Project No.: 018-118D

**PLANS AND DOCUMENTS**  
referred to in the PDA  
**DEVELOPMENT APPROVAL**

**Approval no:** DEV2020/1099

**RE: GEOTECHNICAL SLOPE STABILITY - TECHNICAL NOTE**  
**OXLEY PDA - STAGE 1A**  
**SEVENTEEN MILES ROCK ROAD, OXLEY**

Figure 2: KN Group's concrete lined drain detail

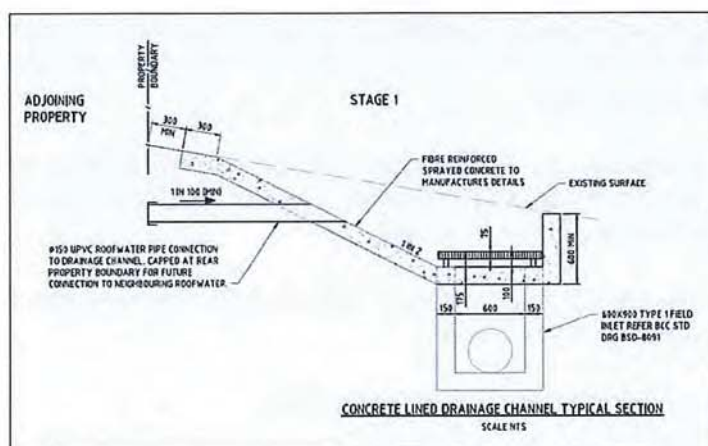
Butler Partners has confirmed with the civil works designer, the scope of subsoil drainage/concrete drain lining required. It is considered that the proposed KN Group's concrete drain indicated in Figure 2 is appropriate for use across the rear of the allotments.

It is understood that drainage lines/swales are to be located within Lots 14 and 20 to convey captured stormwater flow to the road below the allotments; we consider that the swale can be grassed without the need for concrete lining.
